CONGRUENT SOFTWARE, INC.
3998 Whittle Avenue
Oakland, CA 94602
(510) 531-5472

FROM: Peter Johansson
 TO: T10 SBP-2 *ad hoc* Working Group
 DATE: February 14, 1997
 RE: Unsolicited Status Handshake in SBP-2

Figure 1 – UNSOLICITED_STATUS_ENABLE~~STATUS_ACKNOWLEDGE~~ format

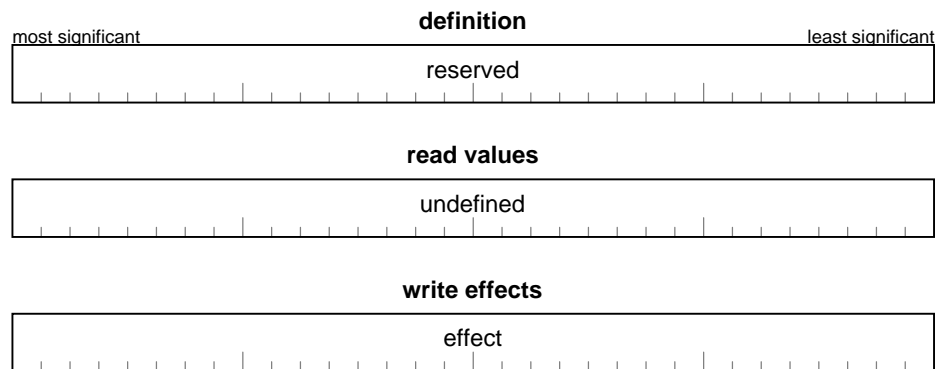
The proposal below represents the working group's opinion, from the January 20 meeting in San Jose, that permission to store unsolicited status should be initially disabled at the time of a login or create stream request. Initiators that wish to accept unsolicited status may subsequently write to the UNSOLICITED_STATUS_ENABLE register each time a single instance of unsolicited status may be stored. The proposed modifications to the SBP-2 Revision 2 clause are shown by change bars.

The UNSOLICITED_STATUS_ENABLE~~STATUS_ACKNOWLEDGE~~ register provides a location at which the initiator may grant the target permission to store an unsolicited status block~~signal the target that unsolicited status has been received~~. The definition of this write-only register is given by Figure 1 below.

A quadlet write of any value to this register shall cause the fetch agent's unsolicited status enabled~~status acknowledgment~~ variable to be set to one. A successful login or create stream request~~isochronous login~~ shall zero~~set~~ the corresponding unsolicited status enabled~~status acknowledgment~~ variable ~~to one~~. As described in 9.4, any time a target stores an unsolicited status block it shall zero the unsolicited status enabled variable for that login. Before the target may store a subsequent unsolicited status block it is necessary for the initiator to write to the UNSOLICITED_STATUS_ENABLE register.
